THE BULLETIN OF THE BEAUX ARTS INSTITUTE
OF DESIGN

NOVEMBER, 1938

A SETTLEMENT HOUSE

JURY REPORT

FIRST MEDAL — G. A. DOWNS

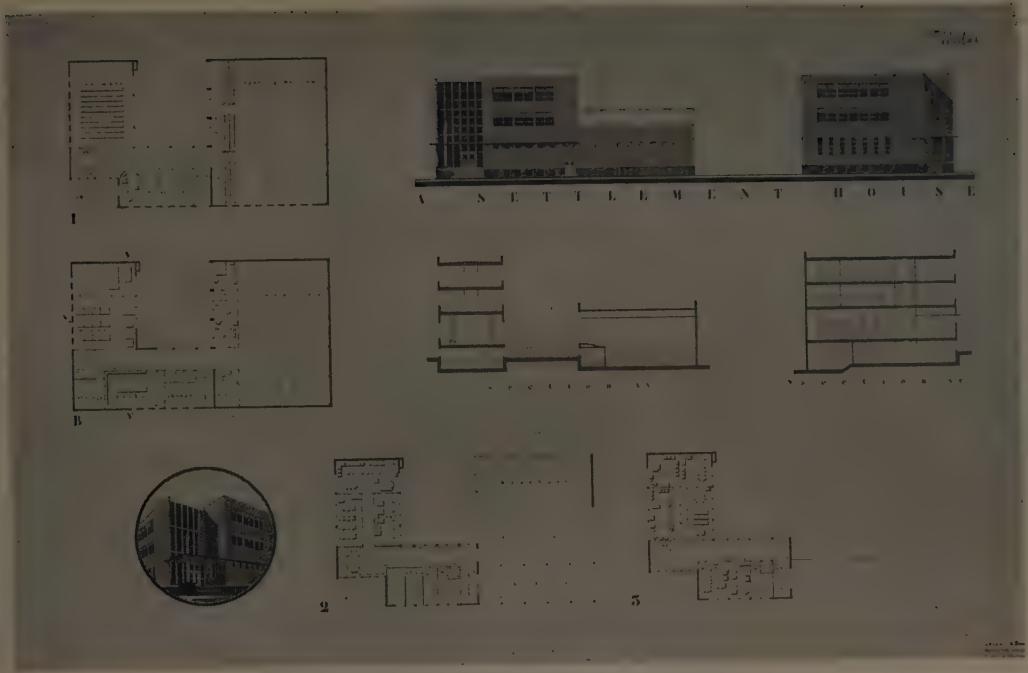
G. A. Downs, Princeton University, First Medal:

Easy entrance, well controlled, directly communicating with assembly room and gymnasium gallery. Large stairs lead directly down to the lockers and the gymnasium floor, located in a partial basement with direct high natural light. There is an attractive interior garden court. Public circulation is easy. Special rooms, like dramatics, painting, and manual training rooms, are well placed. Club rooms are pleasantly grouped; administrative rooms are well separated from other activities. The sections show good volumes. The masses of the building are pleasant. The window openings are not exaggerated, the character is cheerful, and the color agreeable. This was clearly the most commendable drawing submitted.

SECOND MEDAL — C. H. PHILLIPS

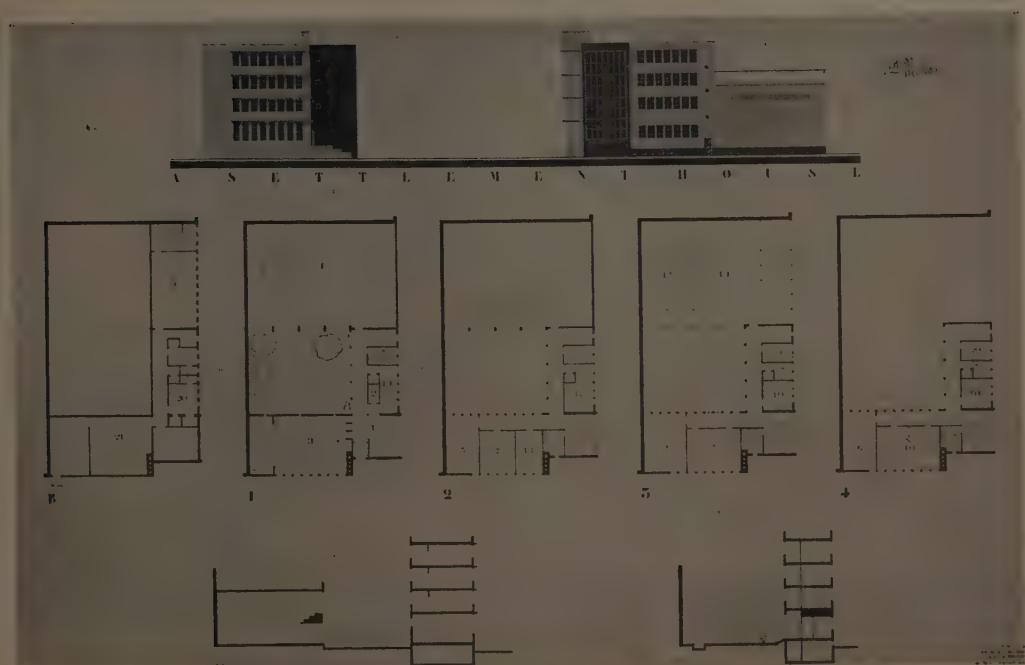
C. H. Phillips, Princeton University, Second Medal:

This scheme closely resembles the one described above, and has many of the same advantages of arrangement. In this case, the gymnasium is on the entrance floor, the lockers one flight below, and the gallery one flight above. This arrangement is not perfect, as the public must climb a story and a half to the gallery, and persons using the gymnasium must first go to the locker room on the lower level. The entrance is somewhat cramped, and the interior court sunk within the building. But the massing is good. The windows lack variety. The color and general character are distinctly attractive.

SECOND MEDAL—R. S. JOHNSON

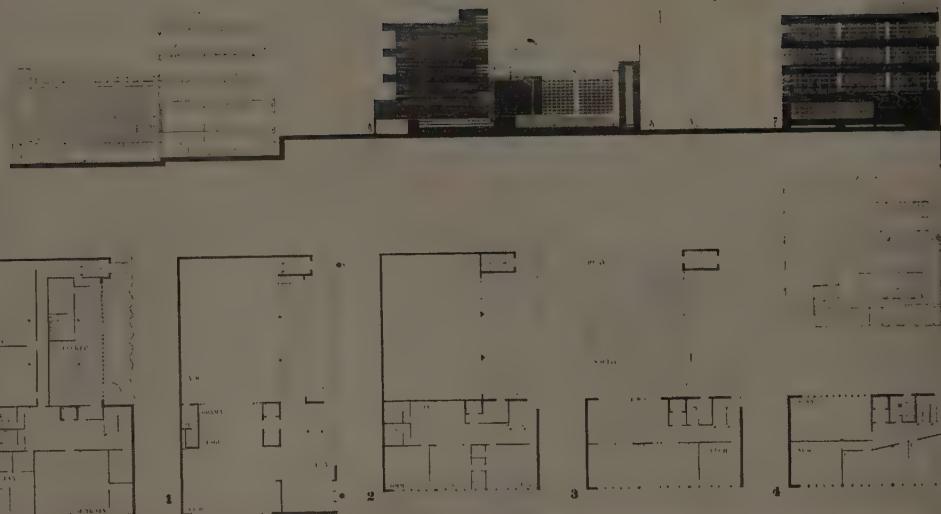
R. S. Johnson, New York University, Second Medal:

Good entrance, good control, good lobby. Clever arrangement of assembly room and gymnasium, with stage between, permitting the utilization, at times of major functions, of a floor area extending the full length and a large portion of the width of the lot. There is but one narrow exterior court; coverage of the lot is therefore nearly maximum. Club rooms are pleasantly grouped about a lobby giving out on a roof deck. The massing of the building is good; the fenestration is interesting, though extravagant.

SECOND MEDAL—F. SCHUHMACHER

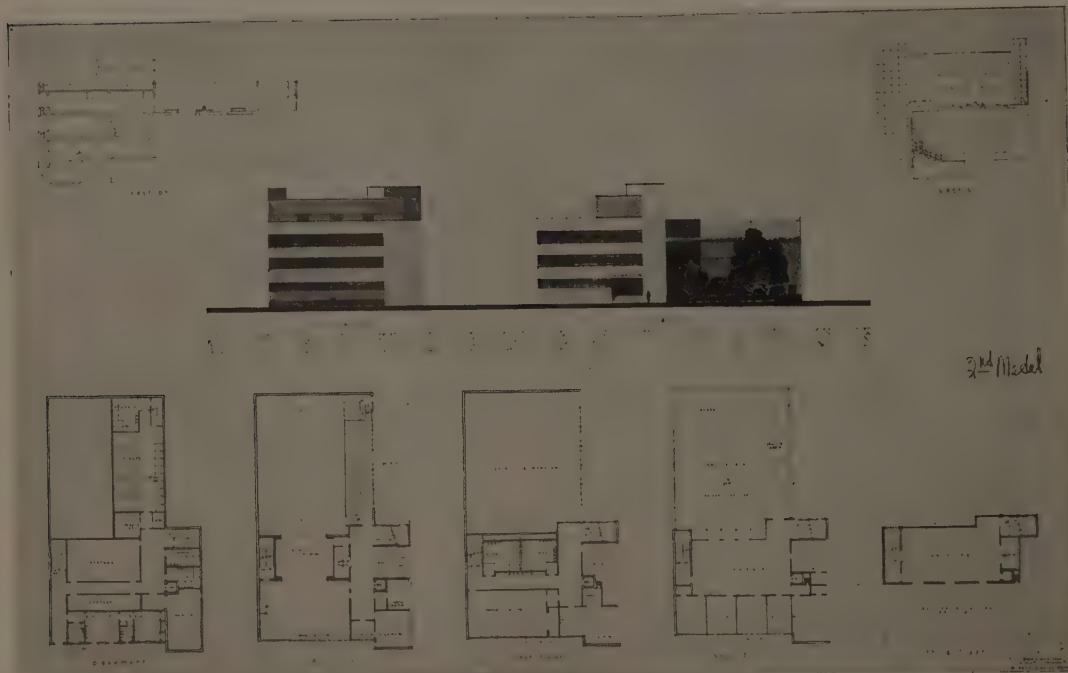
F. Schuhmacher, New York University, Second Medal:

Similar arrangement to the above, with the same good qualities of basic scheme, but with an entrance on the side street, somewhat cramped. Minor defects include toilets with artificial ventilation (considered by the jury to be undesirable in this type of building); basement locker room without adequate ventilation, and painting room of exaggerated size. The banding of windows is monotonous and inexpressive.

SECOND MEDAL—K. S. SLOBODIEN

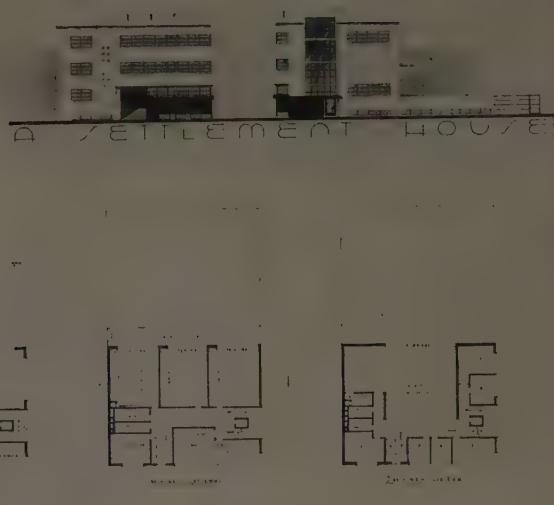
K. S. Slobodien, New York University, Second Medal:

The assembly room is on the entrance floor, the gymnasium lockers are on the floor below. Communication from the lockers to the gymnasium floor is unfortunately through the spectators' gallery. Special rooms located over the assembly room are exaggerated in size, while the club rooms are arbitrarily restricted by the introduction of a patio in the top floor plan. The manual training room is badly placed above the headworker's office. In spite of these defects, the submission was commended for its appropriate character.

SECOND MEDAL—J. E. DUNDIN

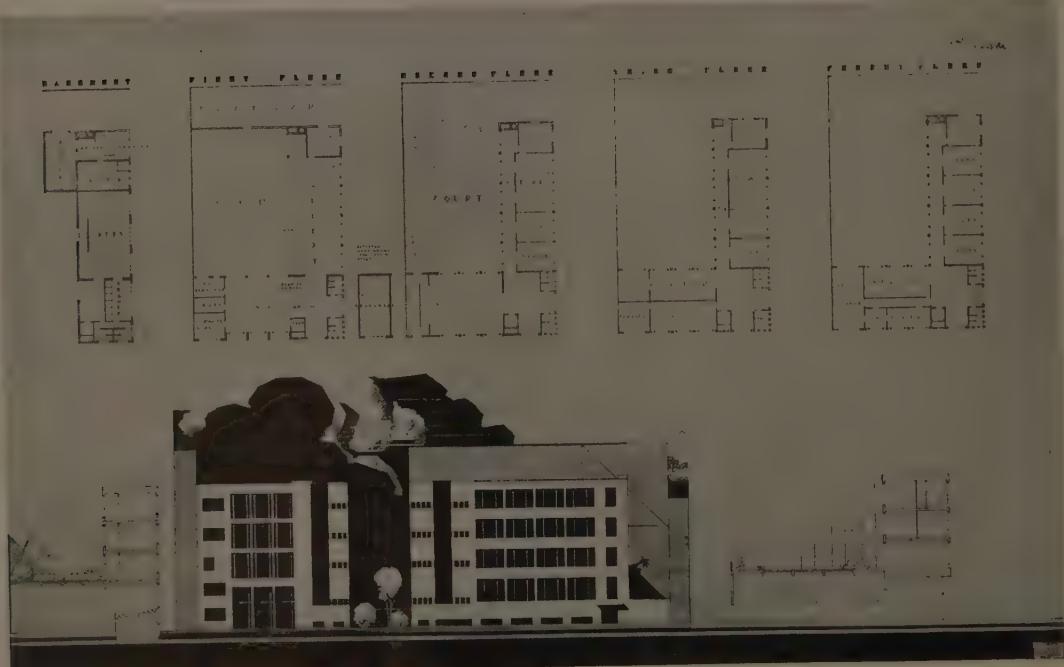
**J. E. Dundin, Catholic University of America, Second
Medal:**

Large area given to gymnasium and gallery on the ground floor; lockers in the basement. The assembly room is one flight up. So far the arrangement is spacious and good. The smaller rooms, however, are poorly arranged and often unsuited to their purposes, as for ex-

ample, the painting room. The elevations are monotonous in the extreme; the patterns and the use of pure black for rendering make them resemble a poster rather than a building.
